Paper for Consideration by ENCWG2
Navtor Response to Presentation of Light description string paper

Submitted by:	
Executive Summary:	This paper highlights discrepancy between the rules given in Presentation Library (edition 4.01) and correspondent test of S-64 (Edition 3.0.1 - June 2015)
Related Documents:	N/A.
Related Projects:	Recently published new editions of S-52 and S-64

Renewed NAVTOR remarks about presentation of Light description string in Presentation Library

But in the correspondent test plot of S-64 (3.1.6 Text Grouping) such Light description is presented without the necessary in this case space (SIGGRP attribute is absent):

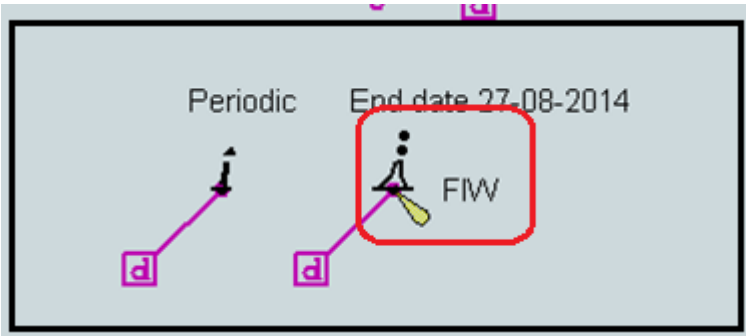
Action
View cell AA5STNDR.000 Switch off all text group controls and switch on only the “Light description” control located under the “Other Text” control. Verify that the objects are displayed correctly as presented in the plot.
Results
The objects are shown as presented in the screen plot below

- a) Improve the presentation for Light description (insert space) in case when the brackets for Signal group number are absent (SIGGRP attribute is absent). For example, for *test plot 3.1.6 (Text Grouping)* it should be: **FI W**.
Same presentation should be in case if SIGGRP is set to 'Undefined' (*Dataset AA5C1PRS (Aid and Services (P, R, S, T))*)
- b) Delete presentation (brackets) for Signal group in case if the attribute SIGGRP is set to '()' or '(1)'. Insert space before Colour description. Replace all correspondent test plots in S-64 and ECDIS CHART 1.
- c) Otherwise, correspondent rule in the chapter 10.6.3 of PL should be re-worded and explanatory notes should be added to Presentation library and test results of S-64.

Test 3.3.9 (Display of additional Chart Information Symbol)

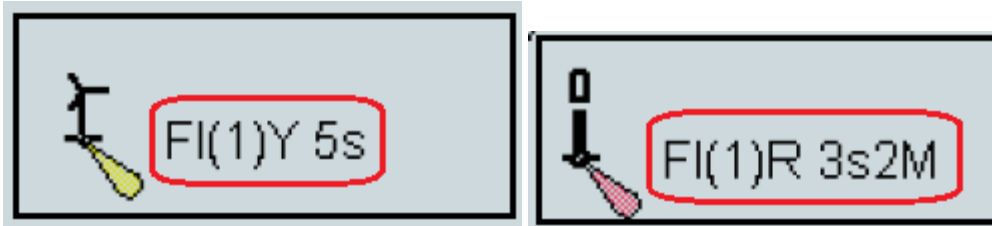
In both cases Signal group is set to '(1)'. Number of signals is presented.
